ADA Curb Ramp New Construction Inspection Form (Parallel)

Main	24952.54			Hillcrest
North-South Road Name	Project No.	Sheet No.	Intersection No.	East-West Road Name

PARALLEL RAMP (PL)

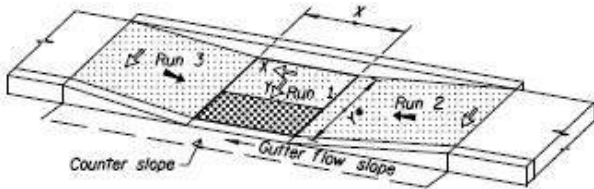
Pass	Fail
RAMP RUN 1			
Running Slope 1	<input type="text" value=""/> ≤ 2.0% <input type="checkbox"/> > 2.0% <input type="checkbox"/>		
Cross Slope 1	<input type="text" value="8.1"/> ≤ 2.0% <input type="checkbox"/> > 2.0% <input checked="" type="checkbox"/>		
Detectable Warning	<input type="text" value="Y"/> Y <input checked="" type="checkbox"/> N <input type="checkbox"/>		
Lip Height	<input type="text" value="0.5"/> ≤ 1/4" <input type="checkbox"/> > 1/4" <input checked="" type="checkbox"/>		
Gutter Flow Slope	<input type="text" value="4.3"/> ≤ * <input type="checkbox"/> > * <input type="checkbox"/>		
Curb Running Slope (avg)	<input type="checkbox"/> <input type="text" value="3.66"/> ≤ 8.3% <input checked="" type="checkbox"/> > 8.3% <input type="checkbox"/>		
Counter Slope (+/-)*2	<input type="text" value="4"/> ≤ 5.0% <input checked="" type="checkbox"/> > 5.0% <input type="checkbox"/>		
Det. warning full width of ramp	<input type="text" value="Y"/> Y <input checked="" type="checkbox"/> N <input type="checkbox"/>

RAMP RUN 2			
Running Slope 2	<input type="text" value="9.9"/> ≤ 8.3% <input type="checkbox"/> > 8.3% <input checked="" type="checkbox"/>		
Length 2	<input type="text" value="7.65"/>		
Cross Slope 2	<input type="text" value=""/> ≤ 2.0% <input type="checkbox"/> > 2.0% <input type="checkbox"/>		
RAMP RUN 3			
Running Slope 3	<input type="text" value=""/> ≤ 8.3% <input type="checkbox"/> > 8.3% <input type="checkbox"/>		
Length 3	<input type="text" value="7.5"/>		
Cross Slope 3	<input type="text" value="2.2"/> ≤ 2.0% <input type="checkbox"/> > 2.0% <input checked="" type="checkbox"/>		
TURN SPACE			
Width X	<input type="text" value="4.95"/> ≥ 4.0' <input checked="" type="checkbox"/> < 4.0' <input type="checkbox"/>		
Length Y	<input type="text" value="6.8"/> ≥ 4.0'*1 <input checked="" type="checkbox"/> < 4.0'*1 <input type="checkbox"/>		
Back of Ramp Obstruction (Y/N)	<input type="text" value="N"/> ≥ 5.0'*1 <input type="checkbox"/> < 5.0'*1 <input type="checkbox"/>

Slope X (Cross Slope 1)	<input type="text" value="8.1"/> ≤ 2.0% <input type="checkbox"/> > 2.0% <input type="checkbox"/>		
Slope Y (Running Slope 1)	<input type="text" value=""/> ≤ 2.0% <input type="checkbox"/> > 2.0% <input type="checkbox"/>		
MISCELLANEOUS			
Clear Width (feet)	<input type="text" value="4.95"/> ≥ 4.0' <input type="checkbox"/> < 4.0' <input type="checkbox"/>		
Intersection Control Type	<input type="text" value="SY"/> Slope of Rd. <input type="text" value="3.8"/>		
Horizontal Gaps	<input type="text" value="No"/> ≤ 1/2" <input checked="" type="checkbox"/> > 1/2" <input type="checkbox"/>

IITD gt2. Hatch in r3. Rr2 no end of walk barricade.
